ISO/IEC 14443-3

AMENDMENT 1
2005-06-01

Part 3: Initialization and anticollision —

AMENDMENT 1: Bit rates of *fc*/64, *fc*/32 and *fc*/16

Figure 1 — Frame delay time PCD to PICC"

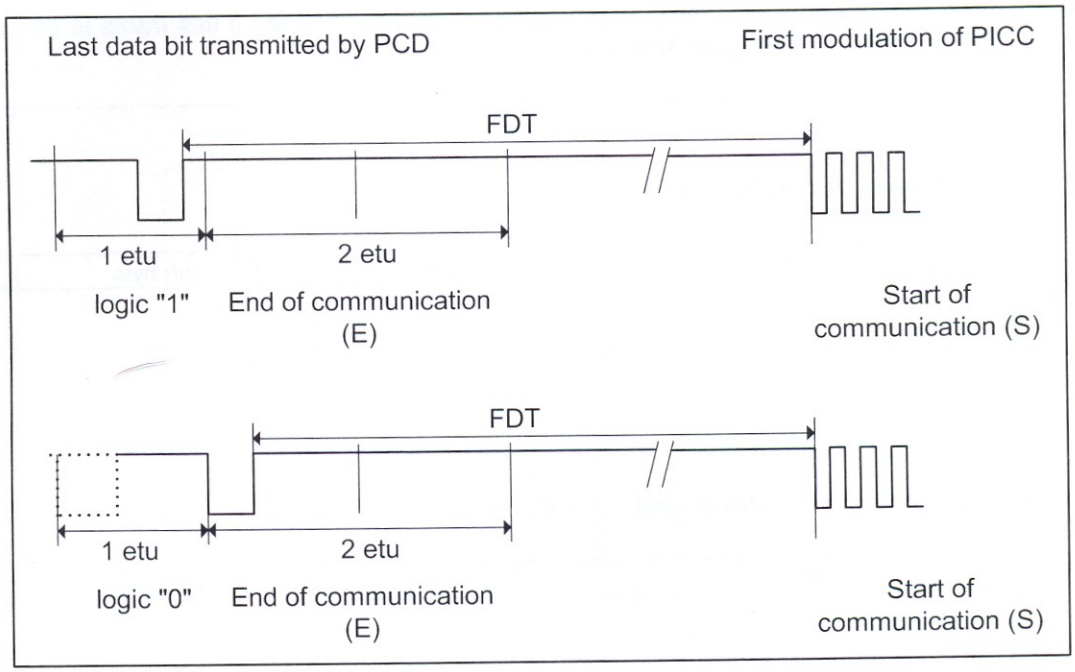
Page 6, subclause 6.1.2 (renumbered to 6.2.2)

Replace Figure 1 with the following:

Figure Amd.1-1 — PICC standard frames"

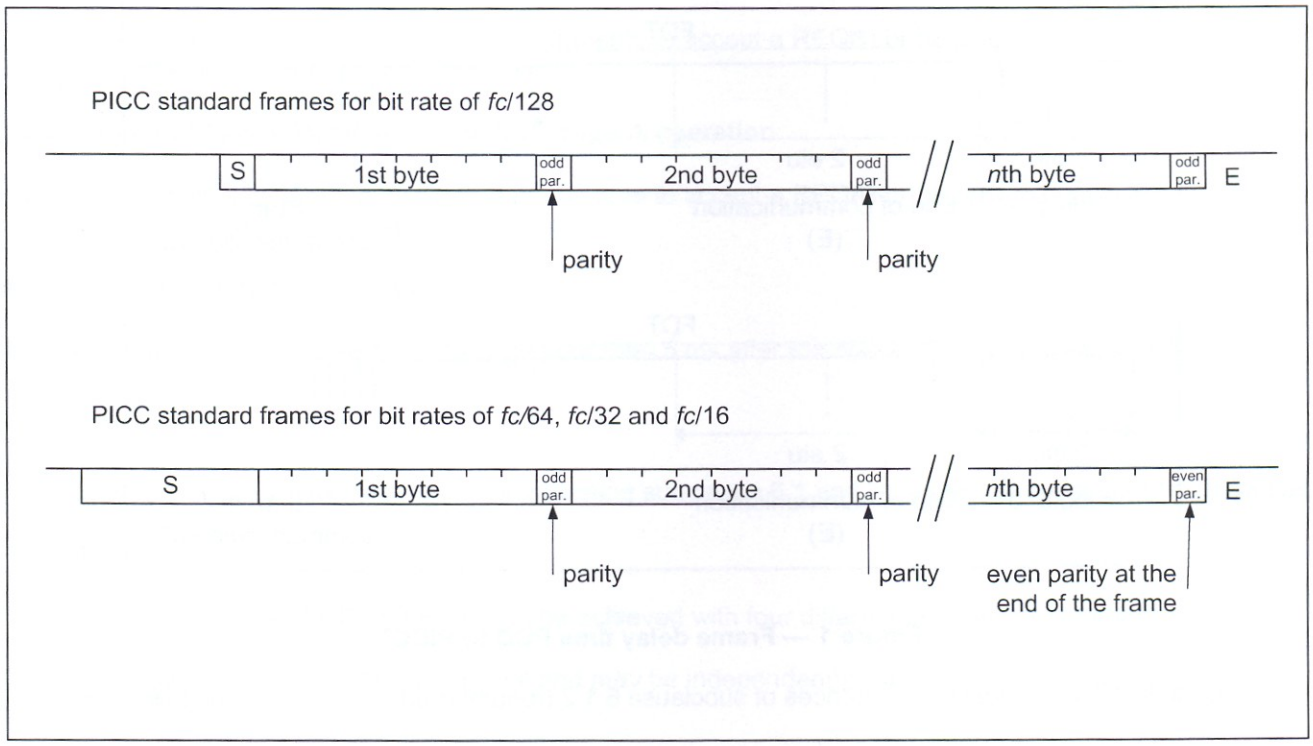
Page 7, subclause 6.1.5.2 (renumbered to 6.2.5.2)

Add the following text and figure after Figure 3:

As an exception the last parity bit of a PICC standard frame shall be inverted if this frame is transmitted with bit rate of *fc*/64, *fc*/32 or *fc*/16 (see Figure Amd.1-1).

Figure 8 — Initialization and anticollision flowchart for PCD"

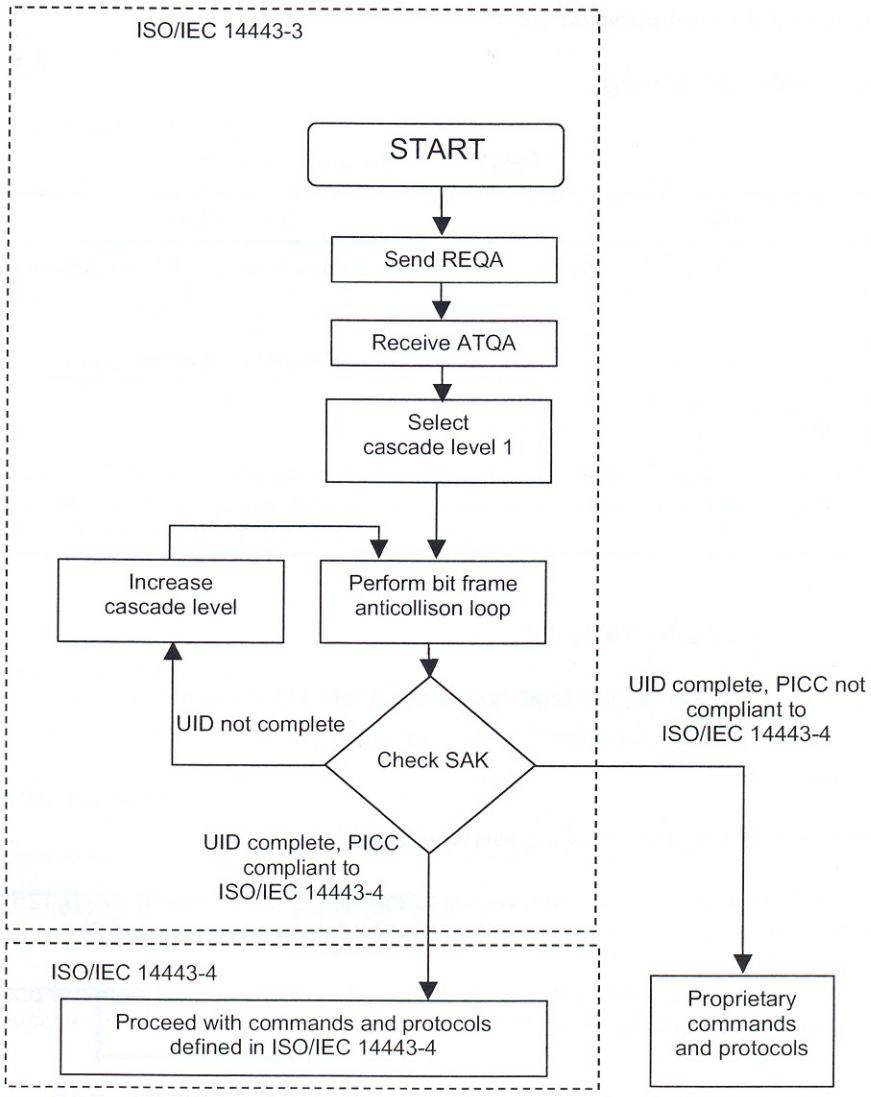
Page 14, Clause 6.4.1 (renumbered to 6.5.1)

Replace Figure 8 with the following figure:

Add the following note and text after modified Figure 8:

"NOTE PICCs may use ATQA bit combinations of b9 to b12 for indication of proprietary methods.

PICCs that do not support the mandatory bit frame anticollision are not compliant with this standard."

Figure 17 — PICC to PCD EOF"

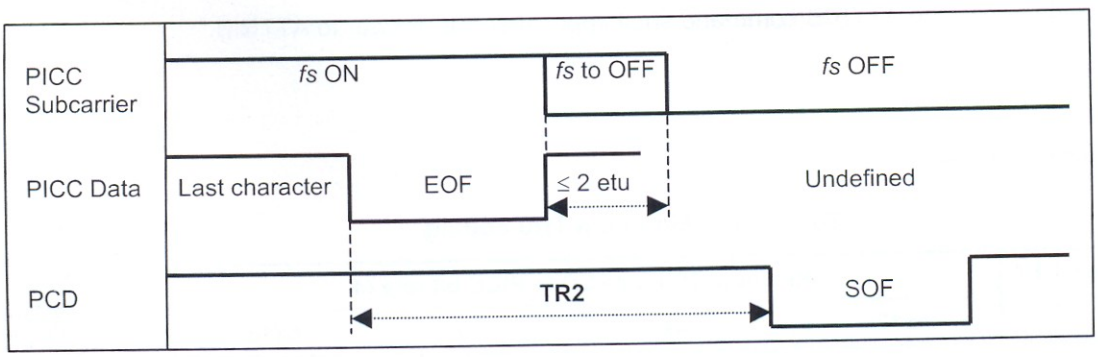
Replace Figure 17 with the following: "
